CITY OF DULUTH

Community Planning Division

File Number	PL 16-125		Contact	Jenn Moses, jmoses@duluthmn.gov	
Type	Planning Review		Planning Commission Date	November 15, 2016	
Deadline for Action	Application Date	October 10, 2016	60 Days	December 17, 2016	
	Date Extension Letter Mailed	October 25, 2016	120 Days	February 15, 2016	
Location of Subject	1740 Mall Drive				
Applicant	Andrew Mack		Contact		
Agent			Contact		
Legal Description	PIN: 010-4427-00012				
Site Visit Date	October 31, 2016		Sign Notice Date	November 1, 2016	
Neighbor Letter Date	November 3, 2016		Number of Letters Sent	13

Applicant proposes a 19,000+ sq. ft. Aldi grocery store, with a brick building and 75 parking spaces, on a site that would be redeveloped from its existing use as a parking lot. The existing parking lot is underused and in poor repair; the grocery store would bring the site into compliance with UDC requirements and improve the general character of this area of the city. The new grocery store is transit accessible with regular service via DTA Route 10.

TITLE
SITE PLAN
SHEET
C2.11

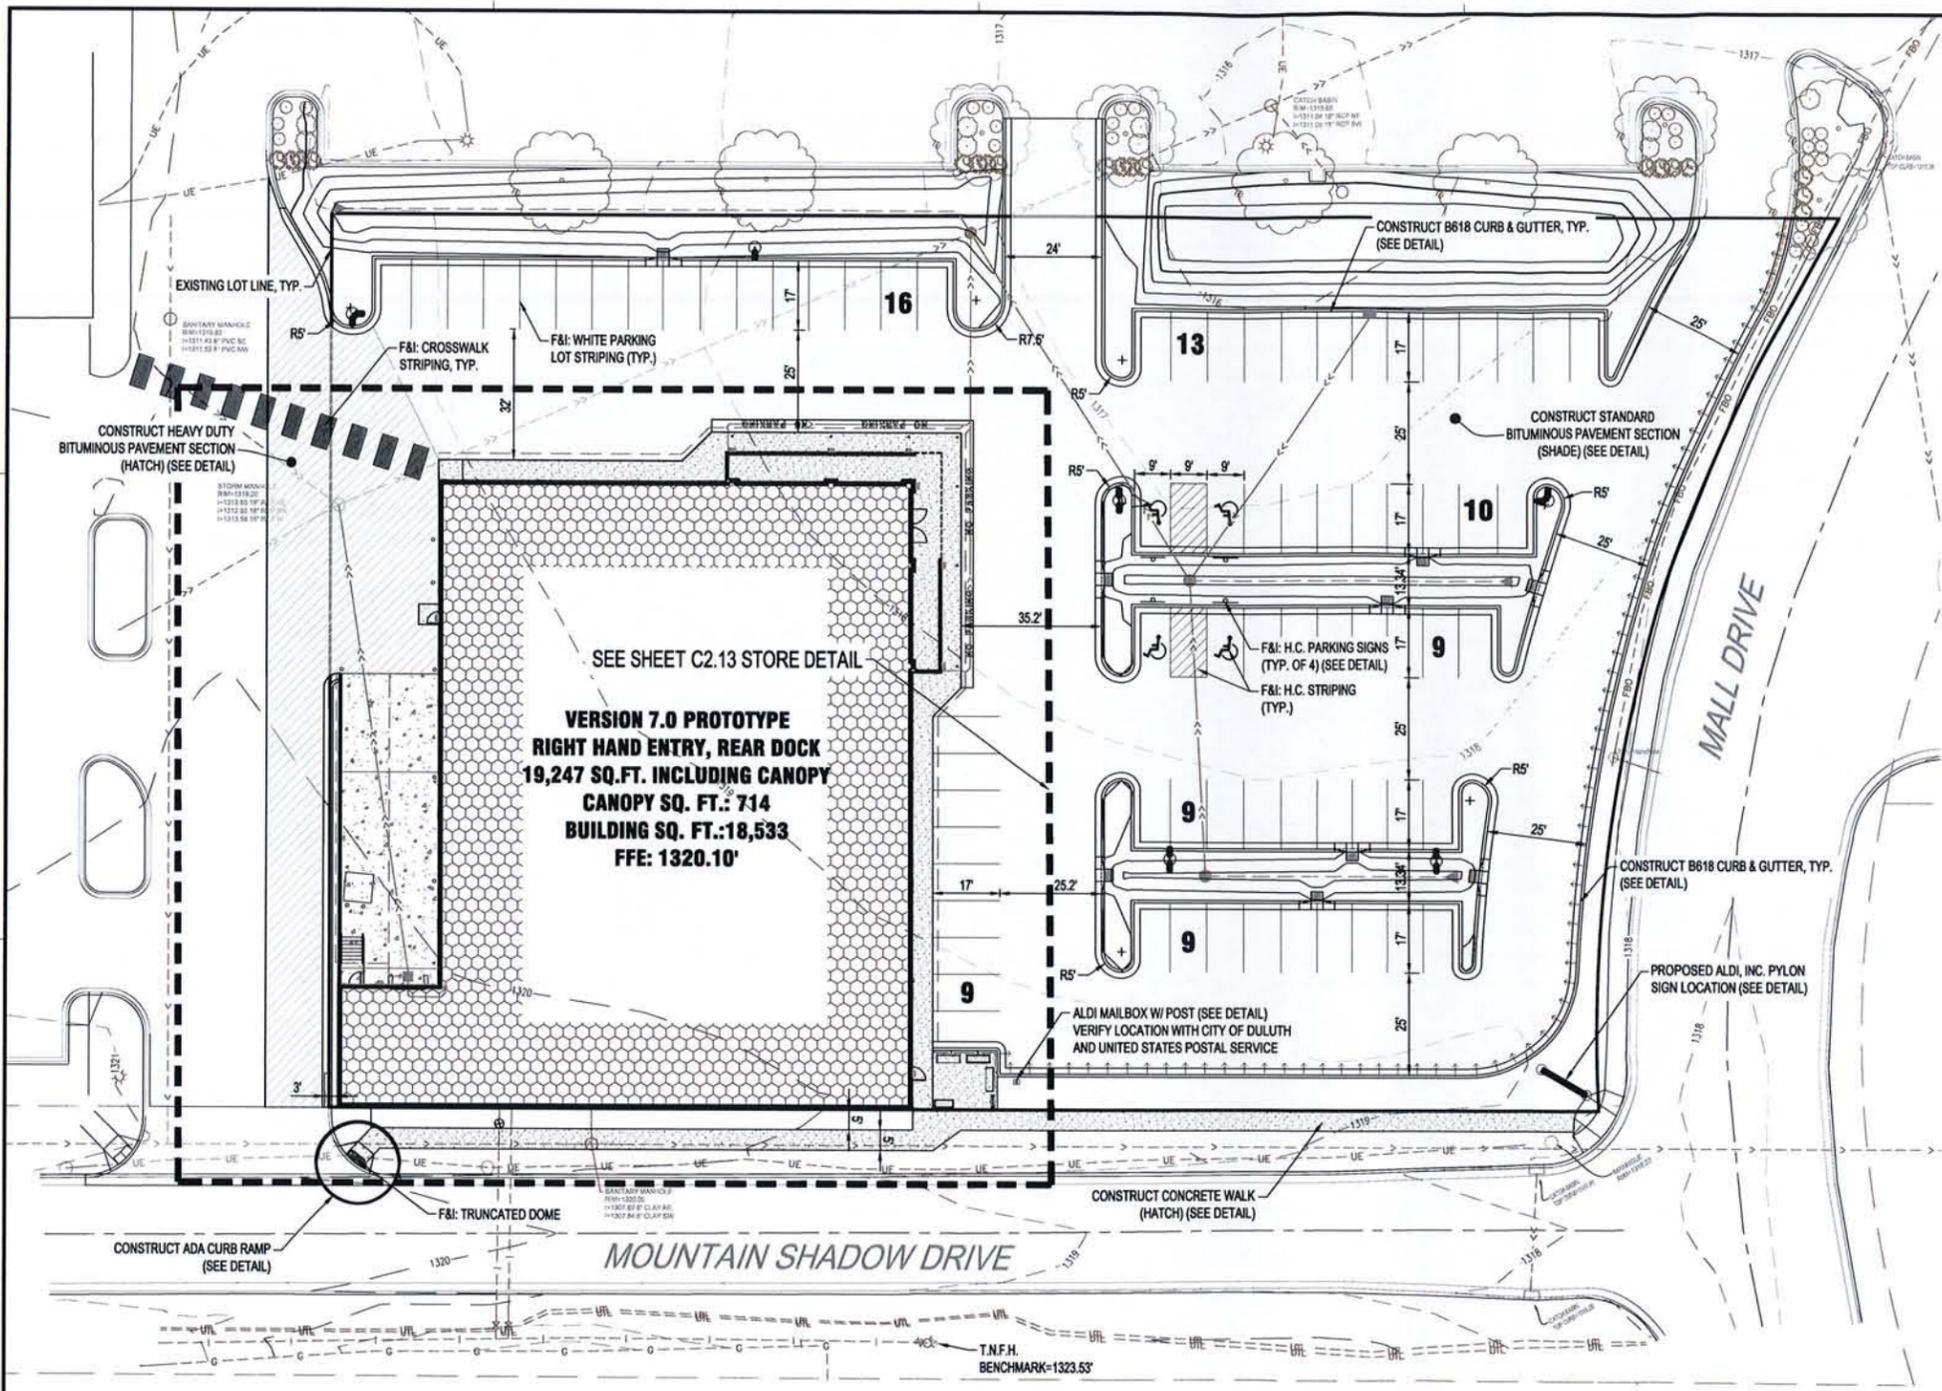
- 2.) 50-23 (Connectivity) – Existing sidewalk along Mall Dr will remain. Project will include a new sidewalk along Mountain Shadow Dr, a sidewalk from Mountain Shadow Dr to the store entrance, and a pedestrian plaza with seating. A crosswalk will be located between the Aldi store and the neighboring Petsmart/Hobby Lobby.

- 3.) 50-24 (Parking) - The parking lot will be resurfaced and restriped, with landscaping and stormwater improvements. Project is proposing 75 parking spaces, which meets all requirements.

- 1.) The project be limited to, constructed, and maintained according to Site Plan (Sheet C2.11), Site Grading Plan (Sheet C3.11), Site Lighting Plan (Sheet C6.11), Landscape and Restoration Plan (Sheet L1.11), all dated 10/07/2016, along with the Exterior Elevations submitted with the application, with amendments allowed to bring project into compliance with landscaping and lighting requirements.
- 2.) Applicant comply with all UDC requirements including but not limited to tree canopy coverage, lighting levels, and sustainability points.
- 3.) Any alterations to the approved plans that do not alter major elements of the plan may be approved by the Land Use Supervisor without further Planning Commission; however, no such administrative approval shall constitute a variance from the provisions of Chapter 50.

SITE LIGHTING PLAN

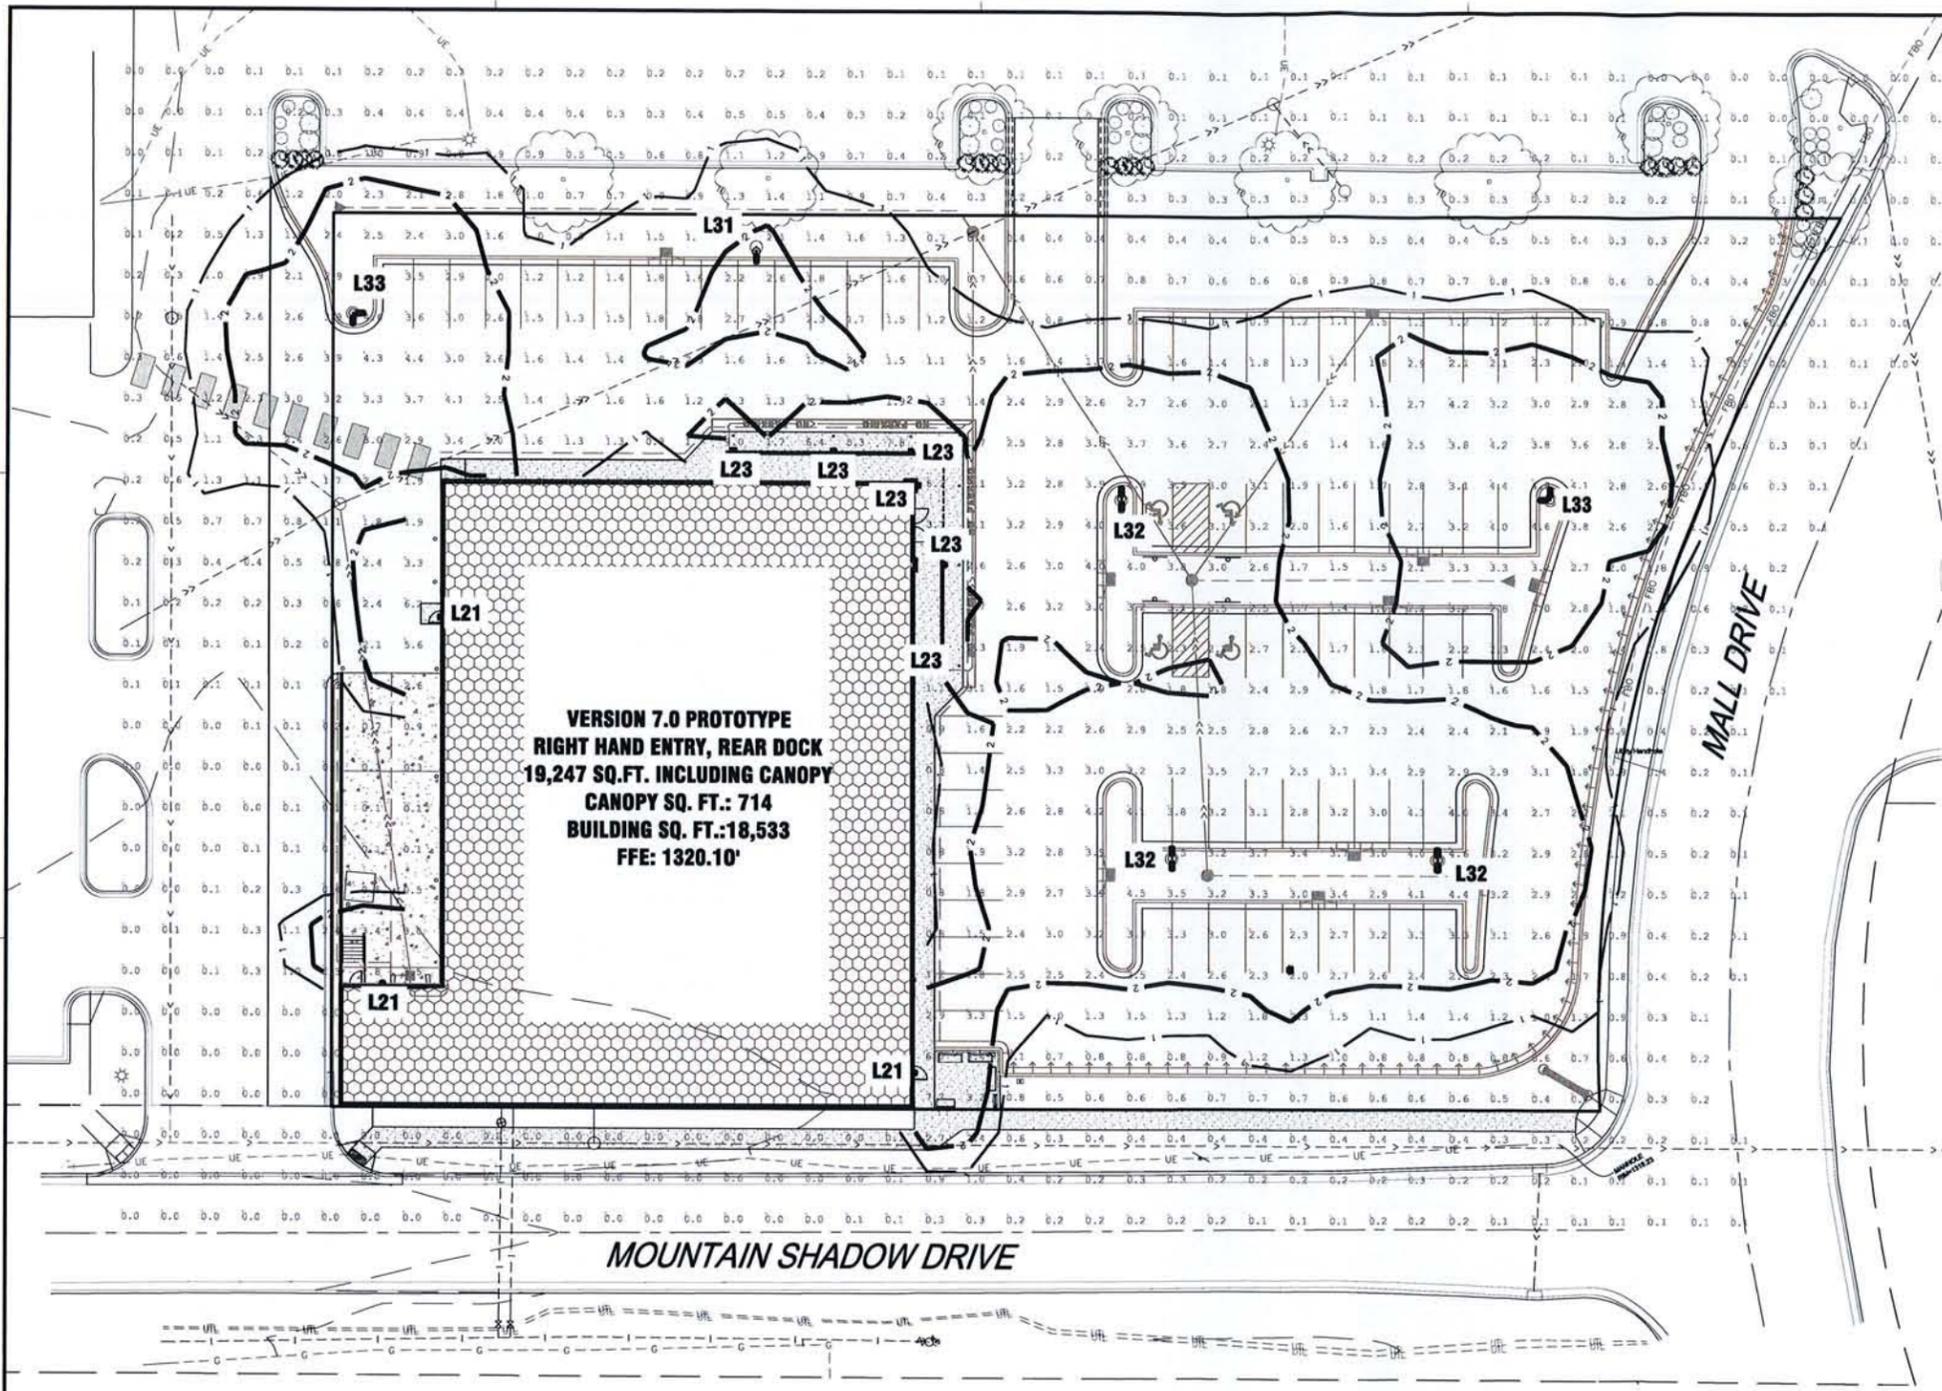
- 10.) 50-31 (Exterior Lighting) – Photometric plan submitted with the application shows elevated light levels along Mountain Shadow Drive and along boundary with Petsmart/Hobby Lobby property. Lights will be full cut-off fixtures.

LANDSCAPE AND RESTORATION PLAN

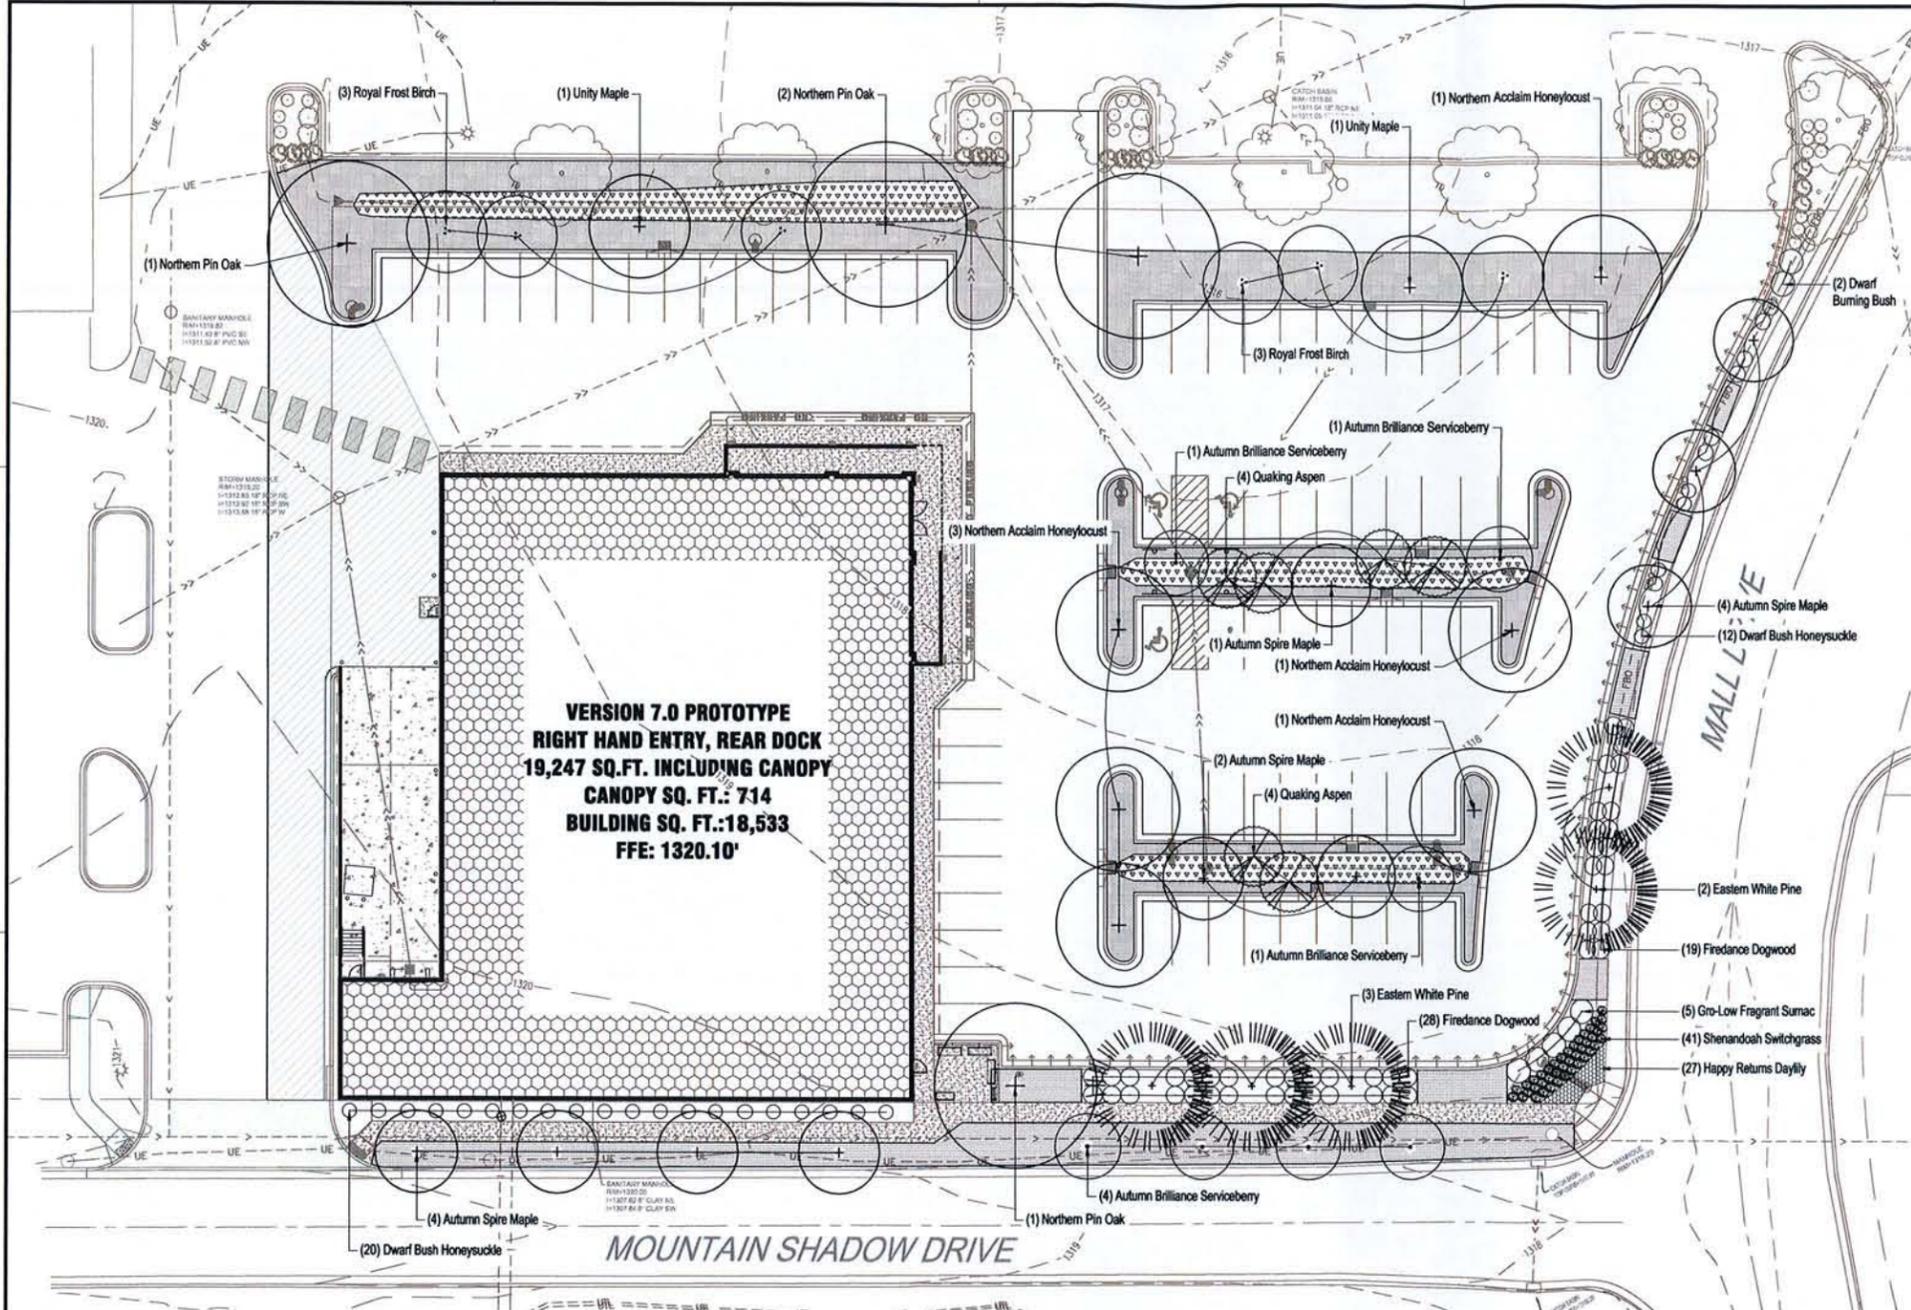
- 4.) 50-25 (Landscaping) - Landscape plan shows that project will exceed landscaping requirements in all areas, including number of trees, number of shrubs, and percentage of interior parking lot landscaping. Applicant will need to demonstrate that the trees shown in the plan will provide 30% tree canopy coverage at maturity.

CEE-1 - SIDE ELEV. - GLAZING CALCULATION	
DESCRIPTION	TOTAL SQ. FT.
NEW STOREFRONT WITH SILL WITHIN 4FT OF GRADE	0 SQ. FT.
NEW STOREFRONT WITH SILL ABOVE 4FT OF GRADE	337 SQ. FT.
TOTAL FACADE AREA	2468 SQ. FT.
GLAZING PERCENTAGE	13.65%
GLAZING PERCENTAGE - SILL WITHIN 4FT OF GRADE	0.00%

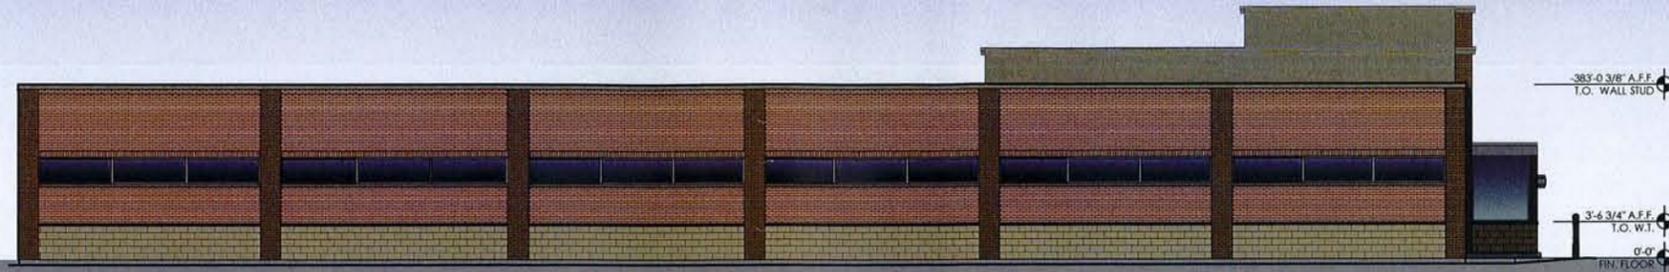
- 8.) 50-29 (Sustainability) - Project will need 3 sustainability points, to be verified at the time of building permit application.
- 9.) 50-30 (Building Design Standards) – The façade along Mall Drive meets the transparency requirements, wall plane articulation option, and vertical articulation option of the building design standards. For the façade along Mountain Shadow Drive, an alternative building design has been approved (see attached).

ISG is requesting approval of an alternate design for the façade facing Mountain Shadow Drive. The alternate design is proposed to be comprised of 13% spandrel glass in lieu of transparent glass since MDU coolers located along the interior of the façade wall, per the building operations plan, do not allow for the use of transparent materials.

In addition, the spandrel glass windows are proposed to be installed at a height of 7 feet above street level in lieu of 4 feet per the Code of Ordinances. However, the façade design incorporates architectural features such as two complementing colors and textures of brick along with the proposed spandrel glass to visually interrupt the wall plane per Section 50-30.2.B.2 of the Code of Ordinances.

Approved: 
10/25/2016
